In the matter of      the Resource Management  
of                              Act 1991 (“the Act”)  
and                            of submissions by Waka  
                                    Kotahi NZ Transport Agency  
                                    (submitter 450 and further  
                                    submitter 62) on the  
                                    Proposed Te Tai o Poutini  
                                    Plan

**Statement of Evidence of  
Robert Swears for Waka Kotahi - Transport Engineering**

Figure 1: Diagram C (Waka Kotahi, 2007, page 216)

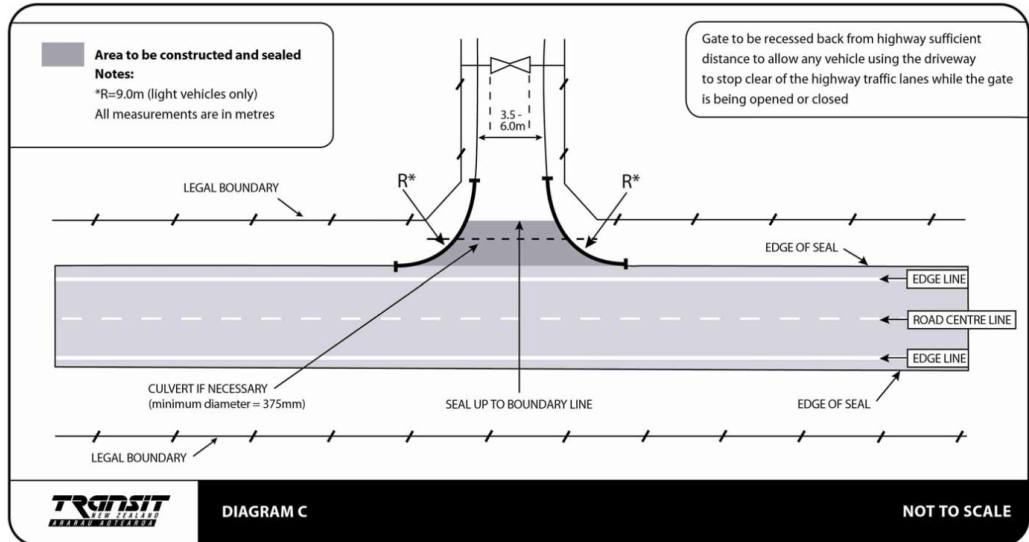
50. For locations on roads within the Region where the speed limit is 70 km/h or more, the minimum accessway design standard should be in accordance with the Waka Kotahi (2007) Diagram C treatment where:

- (i) There will be very few, if any, heavy vehicles (as defined in the Plan) using the accessway. In this regard, “very few” should be taken to mean no more than two heavy vehicle movements per week; and
- (ii) The volume of traffic using the accessway is less than or equal to 30 equivalent car movements per day.

51. In paragraph 50(i) above, the reason I have proposed “no more than two” is because a heavy vehicle needs to be able to enter and depart the accessway, which results in two movements.

Figure 2: Diagram D (Waka Kotahi, 2007, page 218)

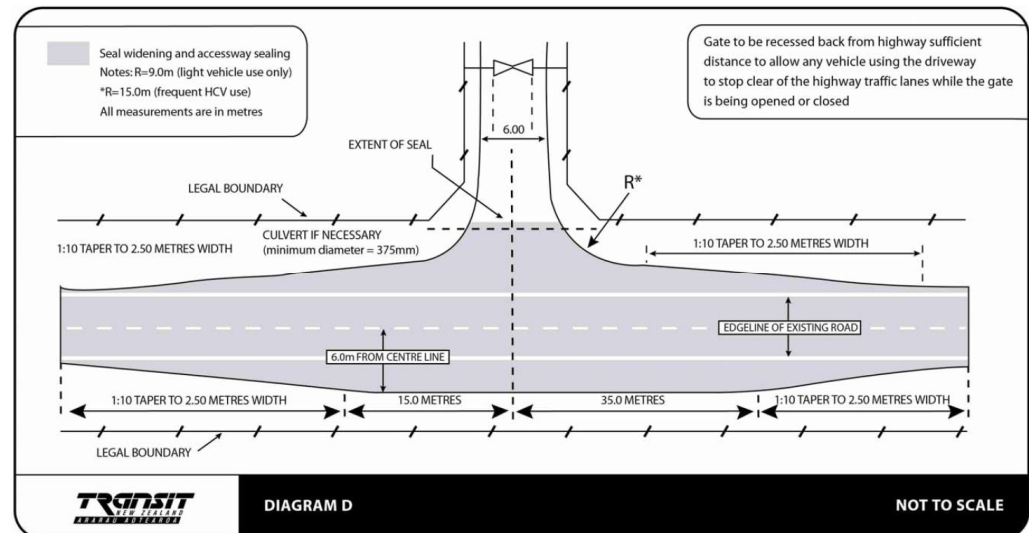
42. There is an important difference between the contents of the PPM and the Waka Kotahi (2022a) submission in that the former refers to Diagram D, while the submission specifically excludes reference to Diagram D. My understanding is that Diagram D is no longer favoured by Waka Kotahi because road users do not appear to have a good understanding of the manner in which a Diagram D treatment should be used.

43. Based on my detailed knowledge of a fatal crash at which a road user did not use a Diagram D treatment in the intended manner, I consider there is merit in the Waka Kotahi approach of proposing to not incorporate the Diagram D treatment in the Plan for locations at which accessways intersect with state highways. However, if Diagram D is not incorporated, the need for a Diagram E treatment at potentially lower turning volumes than described in the PPM becomes more important.

44. Although, based on my experience, there can be issues with the manner in which road users behave at Diagram D access treatment locations, there may be situations on the local road network for which the combined councils consider it appropriate for the Plan to permit the establishment of a Diagram D type access.

Figure 3: Diagram E (Waka Kotahi, 2007, page 220)

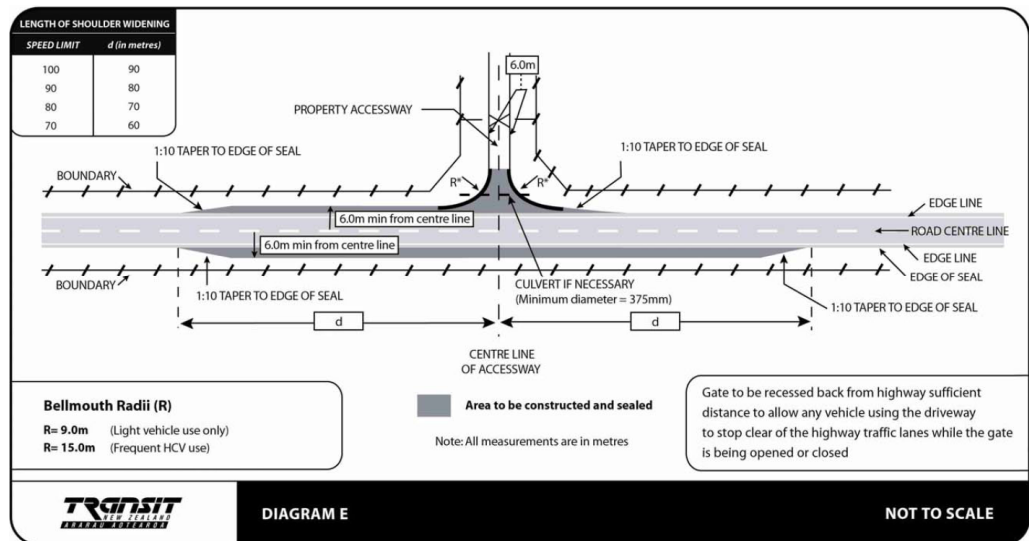
52. For locations on roads within the Region where the speed limit is 70 km/h or more, the minimum accessway design standard should be in accordance with the Waka Kotahi (2007) Diagram E treatment where:

- (i) There will be more than two heavy vehicle movements per week; and / or
- (ii) The volume of traffic using the accessway will be in the range from 31 to 100 equivalent car movements per day.

Figure 5: Perspective B (Waka Kotahi, 2007, page 213)

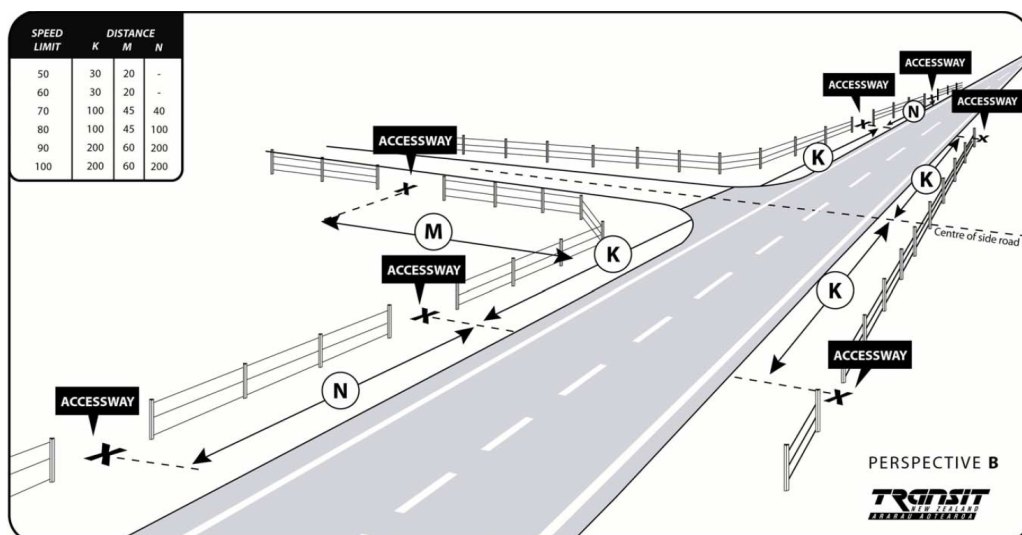
71. In relation to including zones in the Plan to define the minimum separation of an accessway from an intersection, consideration should be given to the types of vehicles likely to be operating within the zone. For example, with reference to Figure 5 above, in a location where the speed limit is 50 km/h, if a 22 m long (MOT, 2016, page 85) multi-unit heavy vehicle is turning from the main road into the side road and then into the first accessway on the side road, there is potential for the vehicle to partially obstruct the intersection as it turns (or is waiting to turn) into the

accessway. Therefore, in zones where there are likely to be multi-unit heavy vehicles, I consider it appropriate for the dimensions identified by Waka Kotahi (2007, page 213) to be increased.

72. Notwithstanding that, I prefer the approach illustrated by Figure 1 of Mr Pearson's statement in relation to the separation along a side road of an accessway from an intersection over that illustrated by Figure 5 of this statement. The minimum side road distance described by Mr Pearson is to the nearest edge of the accessway, rather than to the centre of the accessway (as illustrated by my Figure 5), therefore, Mr Pearson's approach includes a measure of conservatism. However, Mr Pearson's Figure 1 does not illustrate the separation of accessways from intersections along the "main road", nor the separation of accessways from accessways. Therefore, I consider it desirable for a diagram such as Figure 5 of this statement to be included in the Plan to provide clarity for users of the Plan. However, as noted, I have some concerns regarding the adequacy of some of the lengths described in the inset table of Figure 5.
